### STAFF RECOMMENDATION

3707 Katherine Street

**Application:** New construction-infill

**District:** Inglewood Place Neighborhood Conservation Zoning Overlay

SITE PLAN

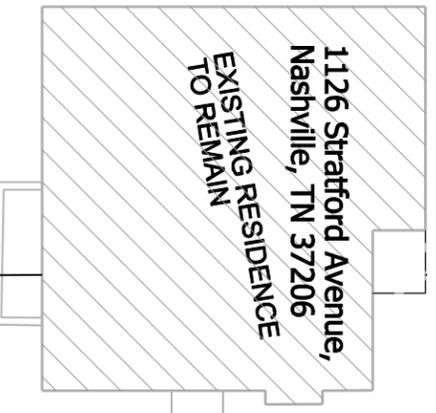
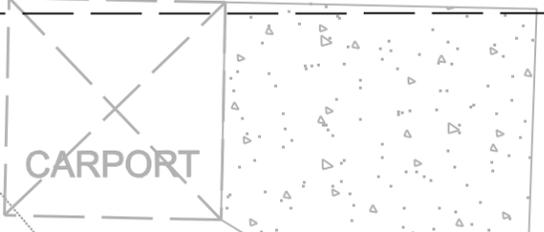
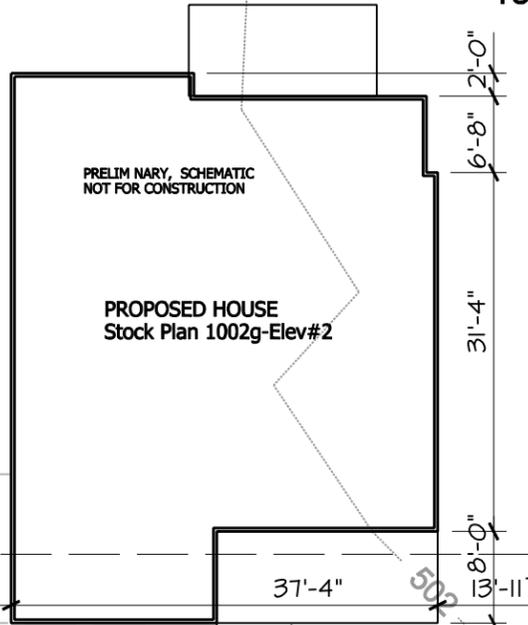
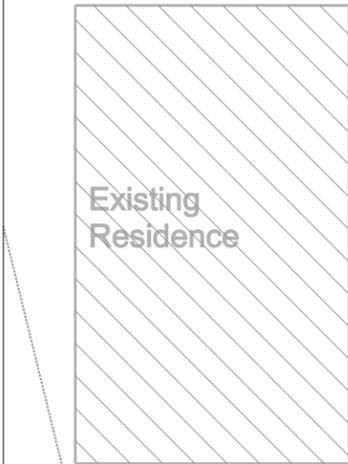
The building width on the site plan is shown as thirty-seven feet, four inches (37'-4") wide at the front while the floor plan shows a building width of thirty-six feet (36'). The applicant has confirmed that the building width shown on the site plan is what is proposed. Staff recommends that the floor plan be revised to show the accurate building width before the preservation permit is issued.

The new infill will be thirty-seven feet, four inches (37'-4") wide at the front setback. The width of historic homes in the immediate vicinity ranges from twenty-four to thirty-four feet (24'-34') wide. While the width of the infill is wider than the historic context, staff finds that it is appropriate as the lot is wider than other lots at sixty-eight feet (68') wide, the new lot is not as deep as the standard lot in the area and is even further truncated by a twenty foot (20') wide easement at that the rear of the property.

Setback & Rhythm of Spacing: The proposed infill meets all base zoning setbacks. The side setbacks will be approximately fourteen feet (14’) on the right and seventeen feet (17’) on the left, which maintains the rhythm of spacing on the street. The rear setback will be thirty feet (30’). At thirty-two feet, six inches (32’-6”), the front setback provides an appropriate contextual front setback that takes into account the front setback of the historic house at 3703 Katherine Street and the side façade of the historic house at 1126 Stratford Avenue that addresses Katherine Street.

Appurtenances & Utilities: This site does not have alley access. The applicant proposes a ten foot (10') wide, single-lane driveway located to the left of the infill. The driveway extends beyond the midpoint of the house, so it will not likely result in "front-yard" parking. The infill also includes a walkway leading from the street to the front porch. The location of the HVAC and other utilities was not noted on the plans. Staff asks that the HVAC would be located on the rear façade, or on a side façade beyond the midpoint of the house, to ensure that the project meets Section III.I. of the Inglewood Place design guidelines.

1. The finished floor height shall be consistent with the finished floor heights of the adjacent historic houses, to be verified by MHZC staff in the field;
2. Prior to issuance of the preservation permit, the floor plan shall be revised to include the accurate building width;
3. Staff approve the final details, dimensions and materials of the roof color, front porch posts and base, front porch railing, deck railing, windows, doors, driveway and walkway material prior to purchase and installation;
4. The HVAC shall be located behind the house or on either side, beyond the mid-point of the house; and
5. Staff approve the masonry color, dimensions and texture.

## FRONT ELEVATION

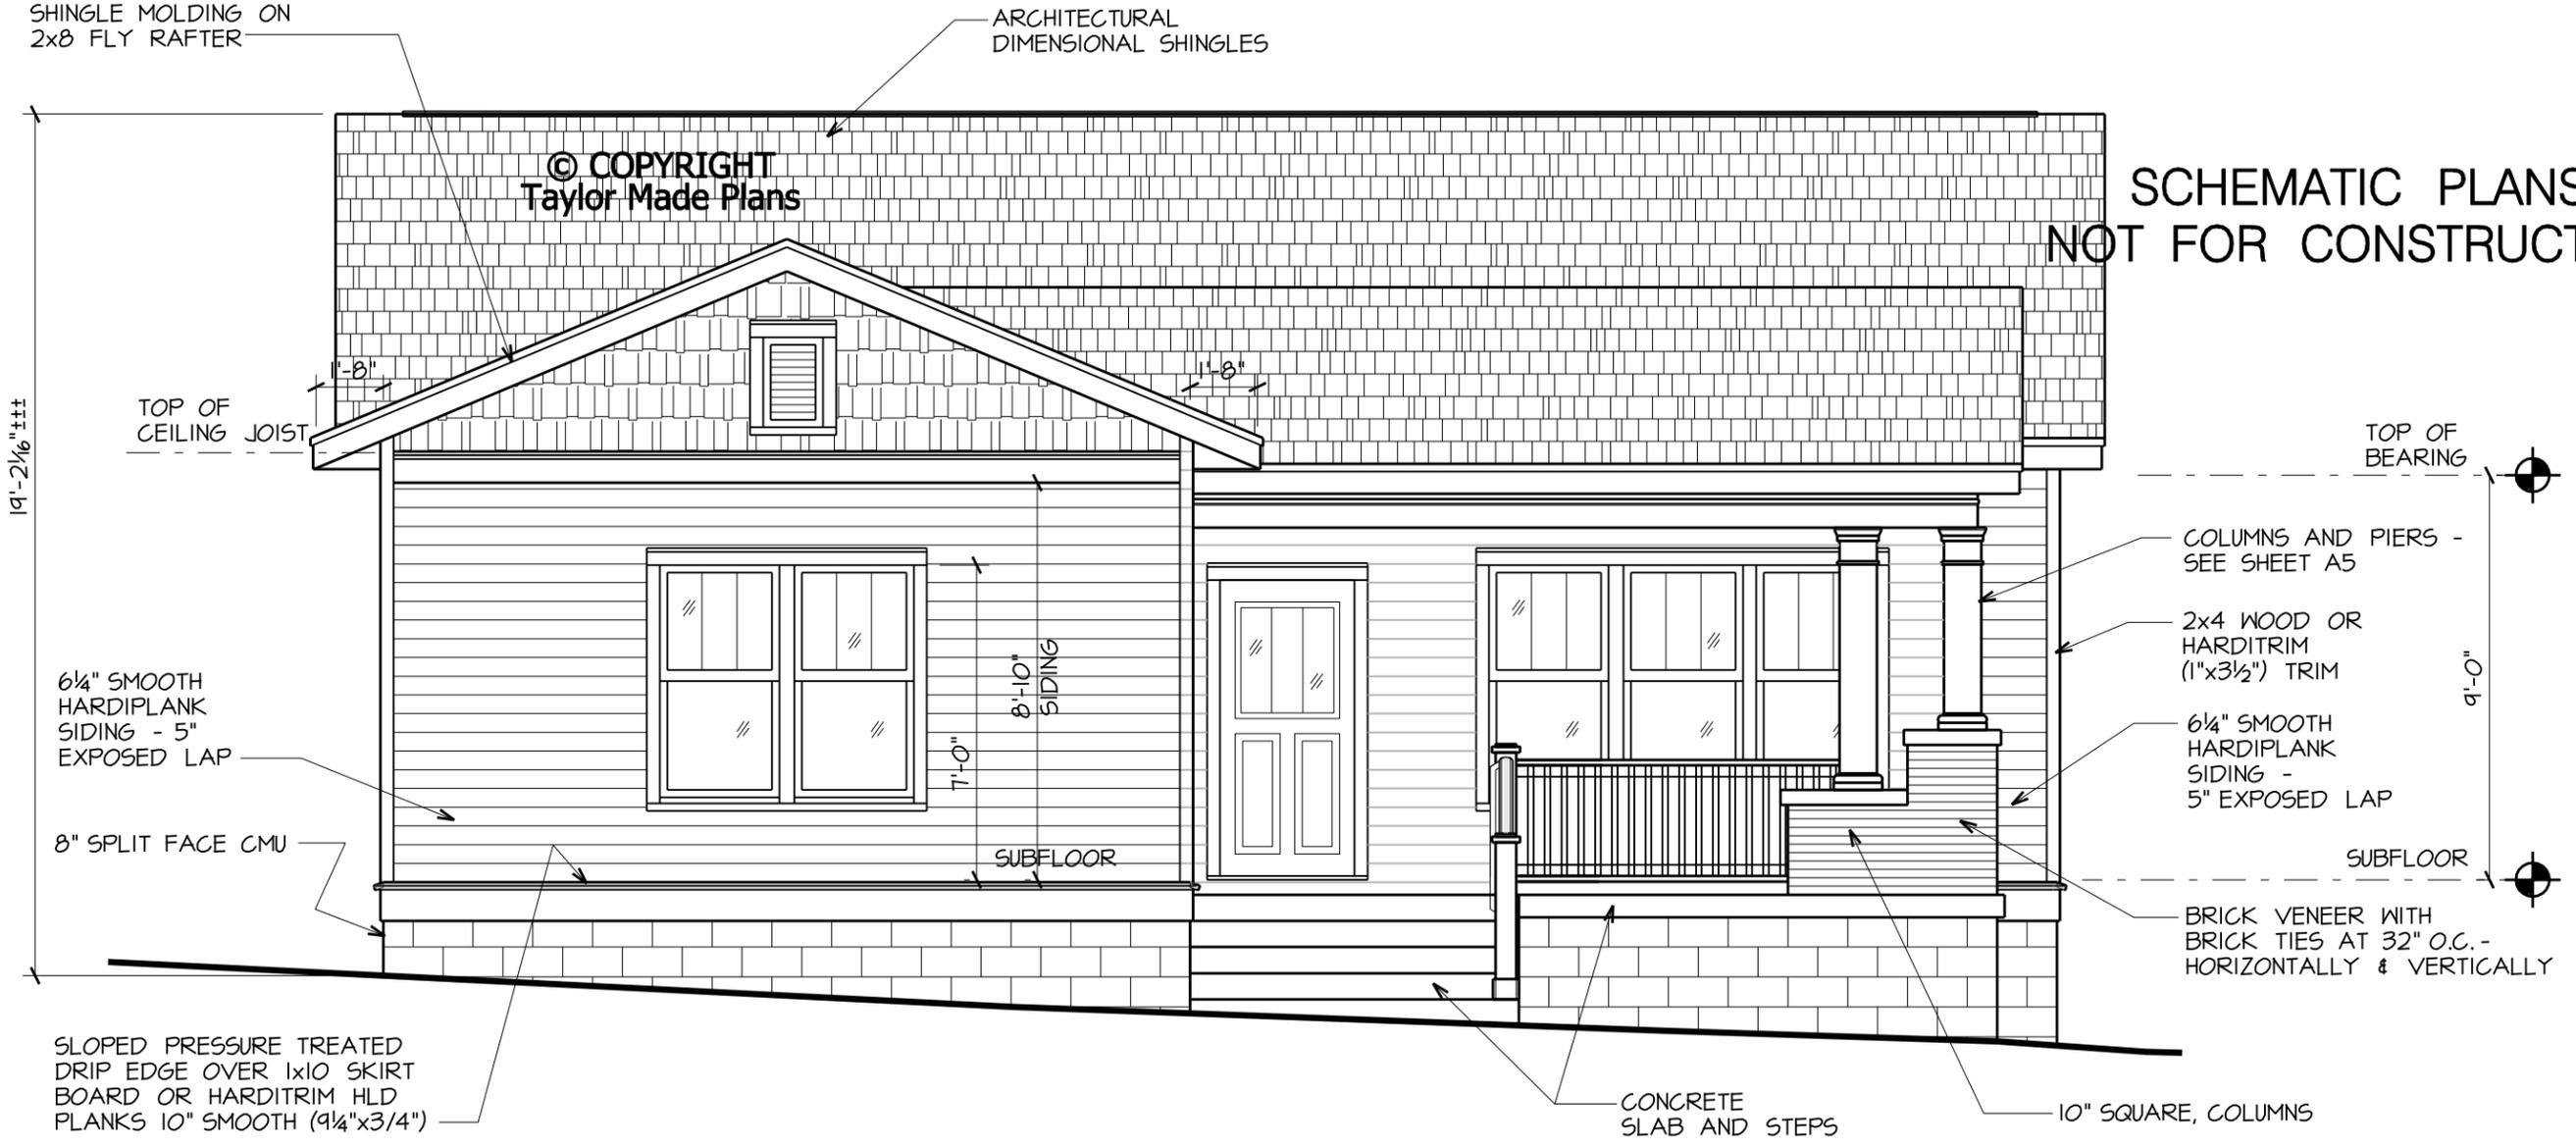
**Height & Scale:** The proposed infill is one-story with an average height of approximately twenty feet (20') from grade, which takes into account a cross-slope located on the site. The proposed overall height is comparable to the adjacent historic houses located at 1126 Stratford Avenue and 3703 Katherine Street, which staff finds to be appropriate for the proposed infill. The infill will have an average eave height at the front of approximately eleven feet, ten inches (11'-10"), which is appropriate for a single-story home.

Orientation: The proposed structure is oriented toward Katherine Street, with a eight foot (8') deep partial width front porch, which addresses the street directly with a walkway connecting it to Katherine Street. Staff finds that the project's orientation meets Section III.F. of the Inglewood Place design guidelines.

Proportion and Rhythm of Openings: The windows on the infill are all generally twice as tall as they are wide, thereby meeting the historic proportions of openings. There are no large expanses of wall space without a window or door opening. On both side façades, the applicant proposes smaller square paired windows. While these windows are not twice as tall as they are wide, staff finds them to be acceptable as they are located on the side façades near the midpoint and will not likely be highly visible from the public right-of-way. Staff finds that the project's proportion and rhythm of openings meet Section III.G. of the Inglewood Place design guidelines.
